In the Matter of)	
)	Docket 50-344
PORTLAND GENERAL ELECTRIC COMPANY,)	
et al)	(Control Building Proceeding)
)	
(Trojan Nuclear Plant))

I hereby certify that on July 10, 1979, Licensee's letter to the Director of Nuclear Reactor Regulation dated July 10, 1979 and an attachment entitled "Request for Additional Information, Trojan Nuclear Plant, Proposed Control Building Design", have been served upon the persons listed below by depositing copies thereof in the United States mail with proper postage affixed for first class mail.

Trojan Nuclear Plant
Docket 50-344
License NPF-1

Enclosed are the answers prepared by Bechtel Power Corporation to the remaining five questions from your letter of May 18, 1979. This submittal answers the last of the formal questions posed by your staff. A revision to PGE-1020 covering updated information will be issued shortly.

Figure 46-10 Secant Modulus, Specimen B-5

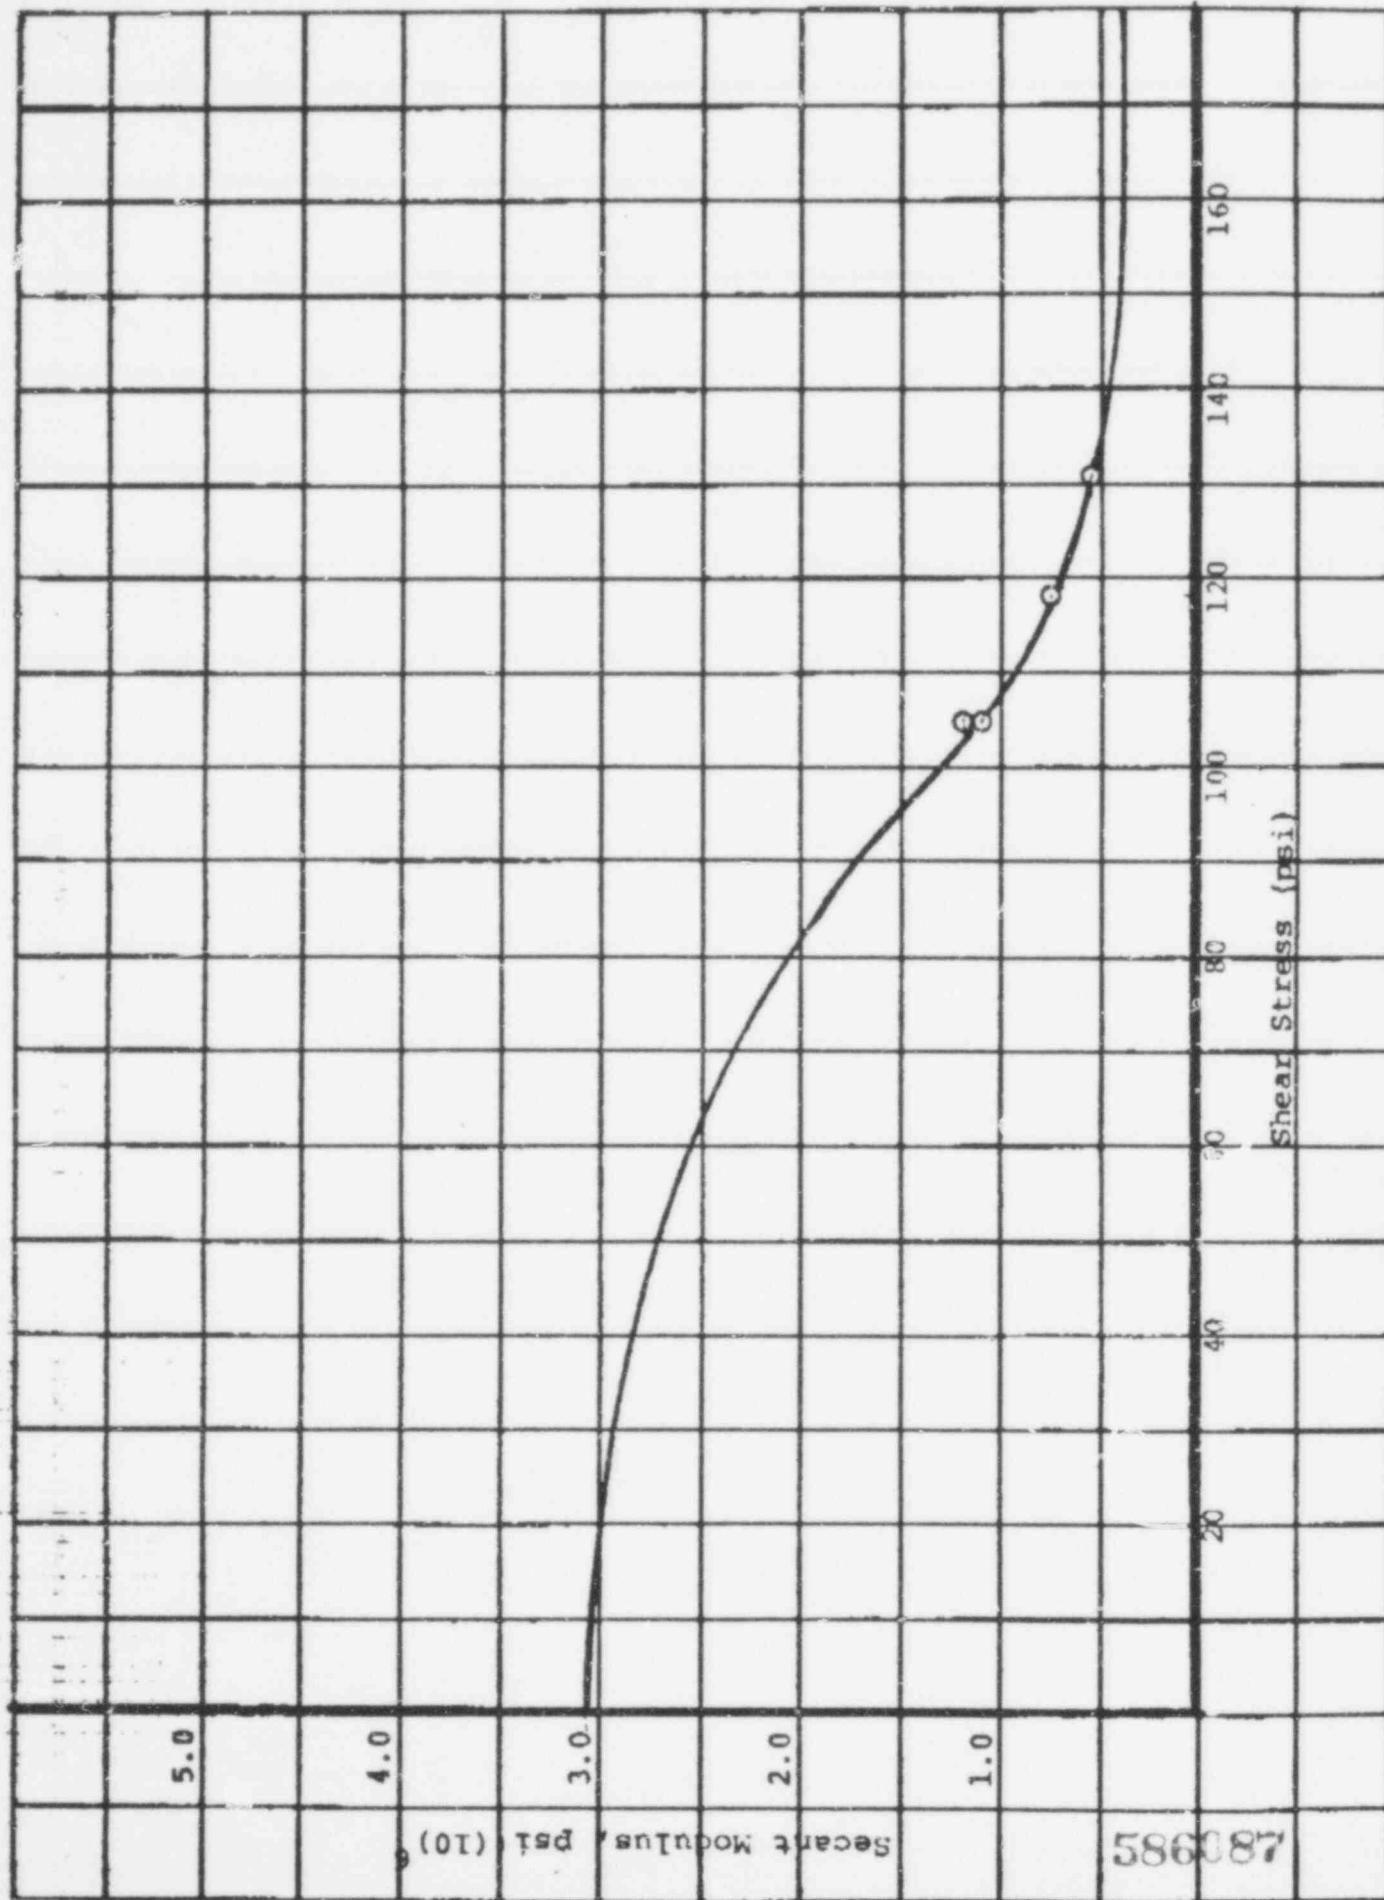
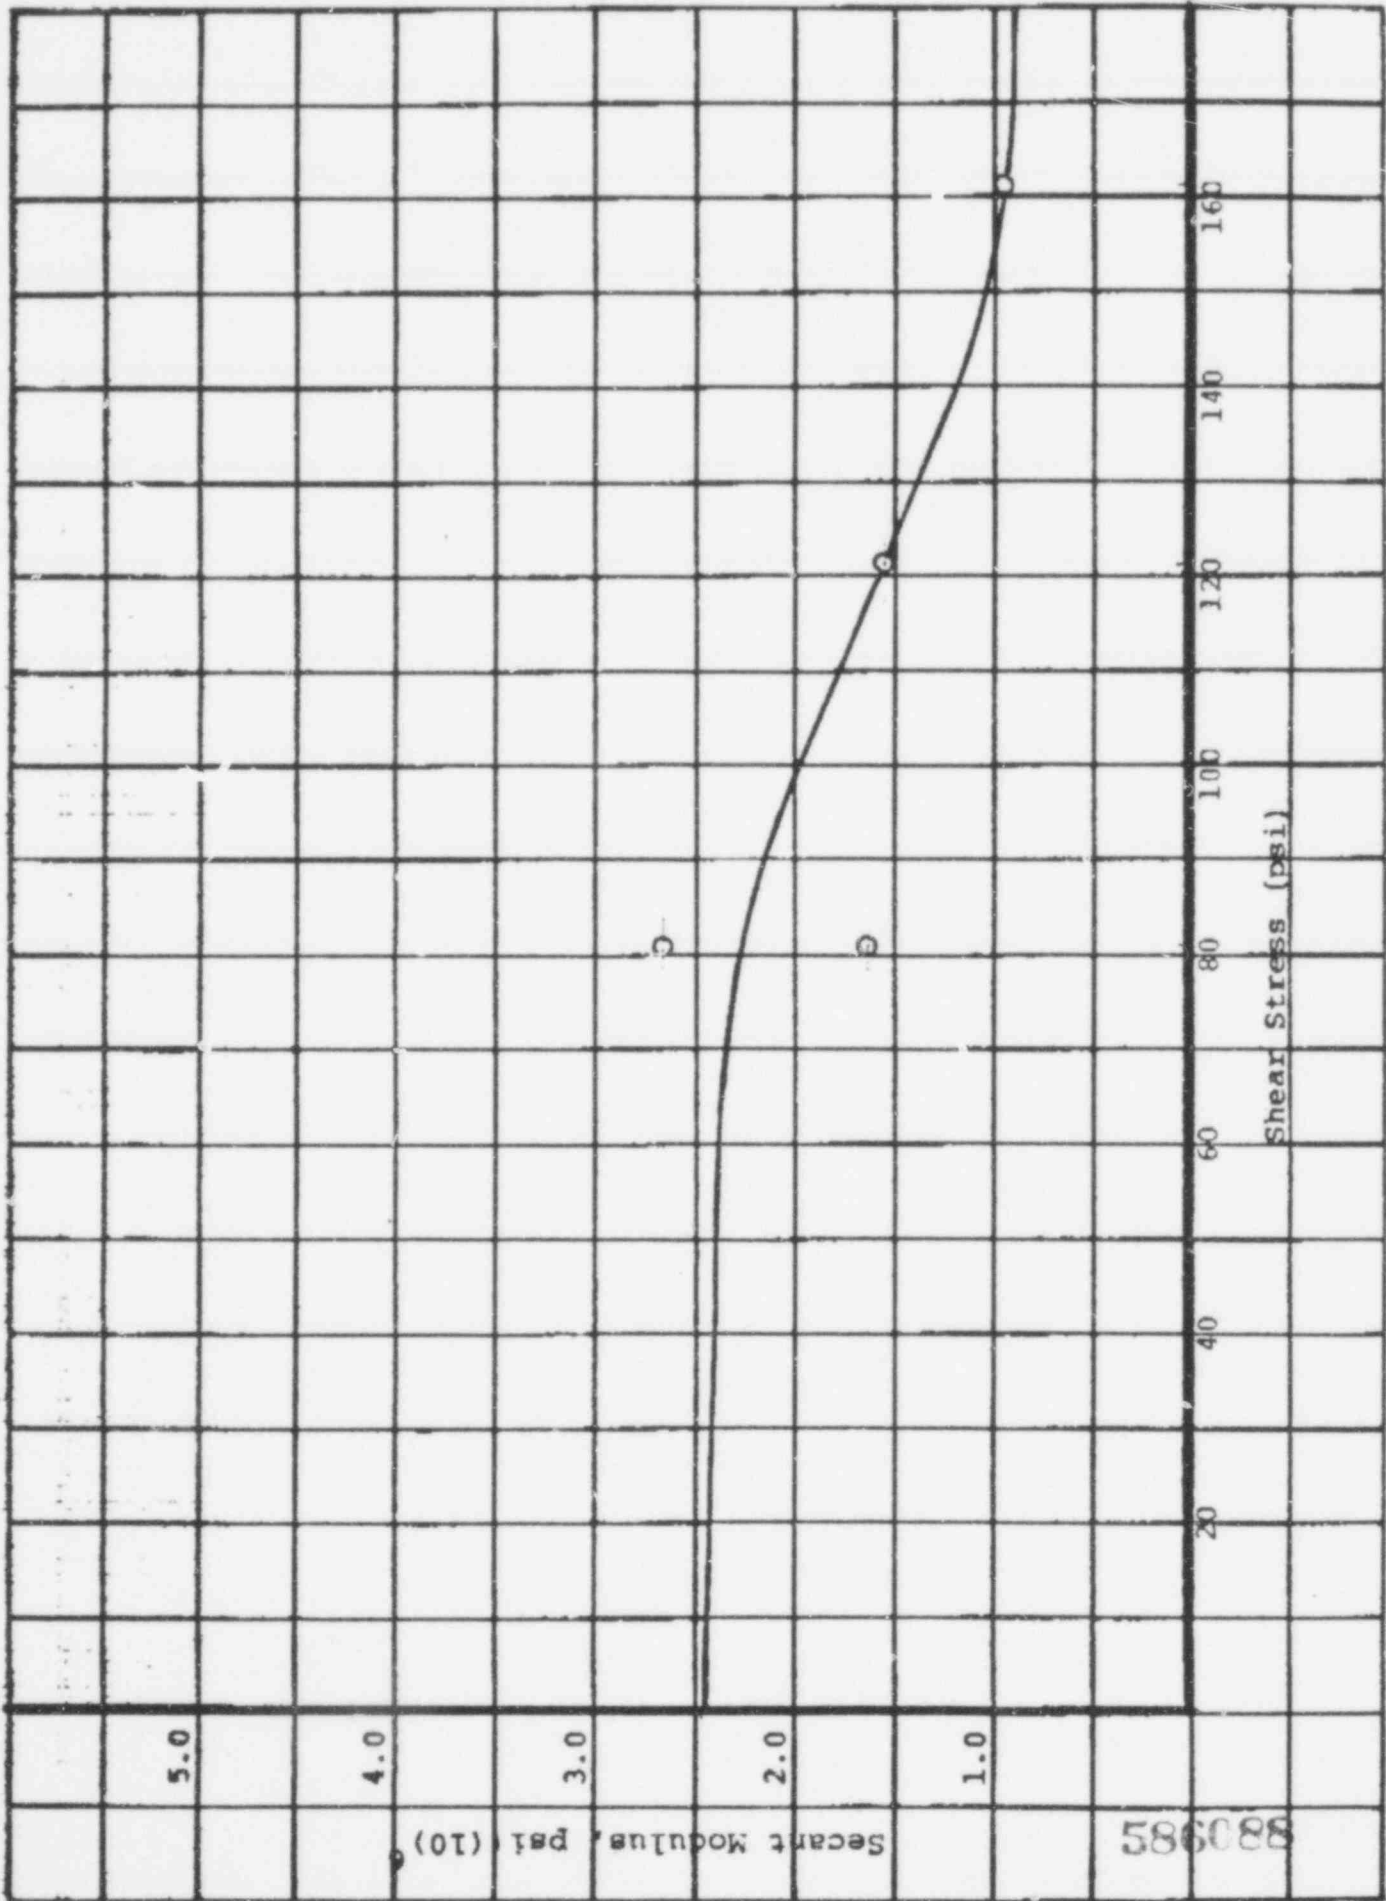
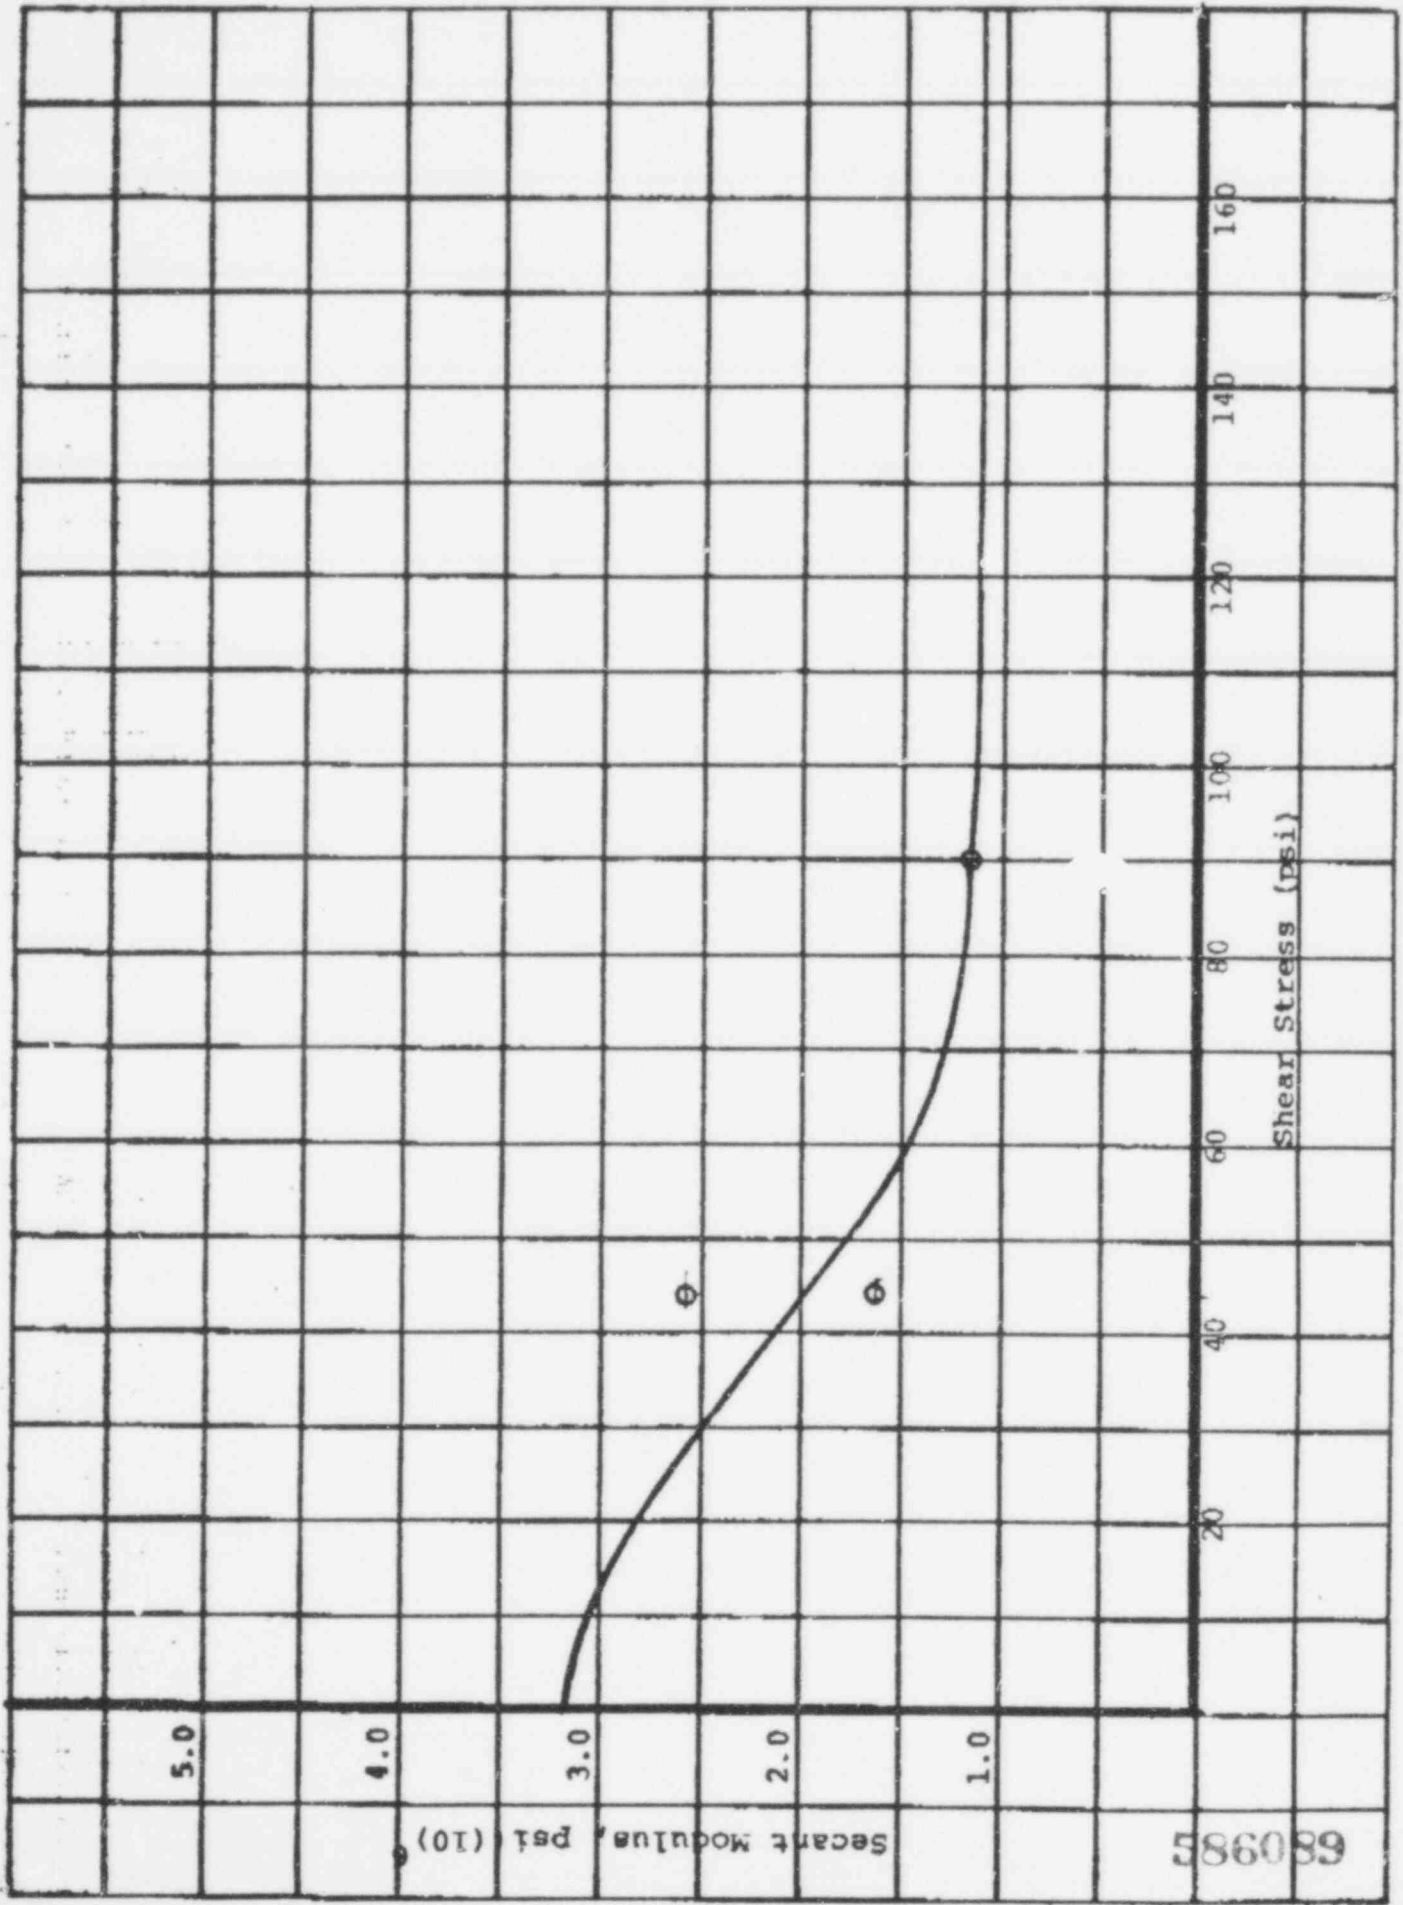
Provide the secant modulus derived for each of the test specimens vs. stress level; a comparison of the experimental initial elastic modulus for the test specimens vs. that calculated using the formula in Section 2.2.1.3.2 of Appendix B; the error bands, and their deviation, for the curves representing stiffness reduction as a function of stress level; and the stresses in each of the walls resulting from incorporation of the stiffness reduction factors in the STARDYNE model along with the associated stiffness reduction factors assumed in the analysis.

The secant modulus vs. shear stress for the test specimens is shown in Figures 46-1 through 46-20. A comparison between the experimental initial elastic modulus and that calculated using the formula in Section 2.2.1.3.2 of PGE-1020, Appendix B cannot be made since the initial modulus cannot be determined experimentally. The instrumentation was not sufficiently sensitive to measure the small deflections required for the calculation. Deflections need to be measured reliably to the nearest .0002 inch at the early stages of deformation. During this stage, the test specimen and load frame is settling in, play in instrumentation is being taken up, etc. Care was taken to minimize these effects but all could not be completely eliminated since the movements being considered are between 1 and 10 times smaller than the thickness of this paper. Some difficulty was even encountered at the first load step but for the other load steps the deflections were

large enough so that effects were not important. As shown in Figures 46-1 to 46-20, there are in general two data points at the first load step. The top part is obtained from the average deflections recorded on each side of the specimen and the other is obtained from the most active dial gauge. The initial modulus used in the plot was calculated using the equation in PGE-1020, Appendix B. An error analysis of the data could not be made since there are not enough specimens with duplicate conditions to provide sufficient data base. The effect of variation is considered in the broadening of the response spectra.
